UNITED STATES PATENT AND TRADEMARK OFFICE

Office Action Summary

10/559,619

DETAILED ACTION

FIG. 3

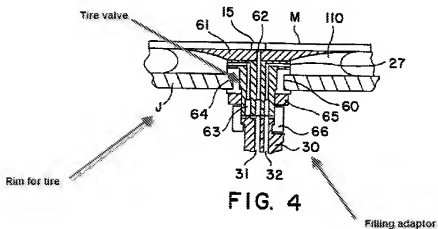
Secondly, regarding claim 1, Taillandier discloses a filling adapter (30) as shown in Figure 3, that includes a first passage (31) that can supply gas to the inner gas chamber by communicating with the air-supply passage for an inner gas chamber, and includes a second passage (32) that can supply gas to the outer gas chamber by communicating with the air-supply passage for an outer gas chamber so as to make a pressure difference between the outer gas chamber and the inner gas chamber, the engaging portion allowing the filling adapter to be mounted so that the air-supply passage for an inner gas chamber communicates with the first passage and the air-supply passage for an outer gas chamber communicates with the second passage.

Taillandier discloses that the filling adapter (30, see appended Figure 4 below) with a coupler (66), which engages with a valve for a safety tire wherein the filling adapter is adapted to charge gas from a gas supply source into the outer gas chamber and into the inner gas chamber via the air-supply passage for an outer gas chamber and the air-supply passage for an inner gas chamber (this limitation "for a safety tire...for an inner gas chamber" is considered as an intended use statement bearing no patentable weight), the filling adapter comprising, a main body portion (30) engaging with the valve for a safety tire, a second coupling (33) provided in the main body portion and including a valve core (36) connectable to a pressure source (through 34) to allow gas from the pressure source to be supplied to the tire, an air chamber (31) provided in the main body portion and connected to the second coupling, a first passage (15, 31) provided in the main body portion and causing the air chamber and the air-supply

passage for an inner gas chamber to communicate with each other, a second passage (32) provided in the main body portion and causing the air chamber and the air-supply passage for an outer gas chamber to communicate with each other, and differential pressure setting means (43, piston, Col.4, Lns. 10-15) provided in the second passage and distributing gas from the gas supply source to the first passage and the second passage so as to generate a pressure difference there between, and a first coupling (49,50) connected to the second passage and allowing gas in the outer gas chamber to be released to the atmosphere by carrying out a predetermined operation (such as the operation of removing 49 and 50).

Regarding claim 5, Taillandier discloses a main body portion (30, see Figure 3) and operating means (the face of 30 near the openings of 15, 27) of Taillandier engages with the valve of Bronson, which is capable of performing the causing of gas in the inner gas chamber and gas in the outer gas chamber to be released to the atmosphere so as not to expand the air pocket, by carrying out a predetermined operation (such as the connection of the device) with respect to the non-return valve member for an inner gas chamber and the non-return valve member for an outer gas chamber of the valve for a safety tire when the main body portion is engaged with the valve for a safety tire.

Regarding claim 8, Taillandier discloses in combination with Bronson and Hawkes that the pressure releasing method according to claim 7, wherein the operating means includes a first protruding portion for operating the non-return valve member for an inner gas chamber, and a second protruding portion for operating the non-return valve member for an outer gas chamber, and the first protruding portion (the protruding portion of 45 is longer than 49, as shown in Figure 3) is longer than the second protruding portion.
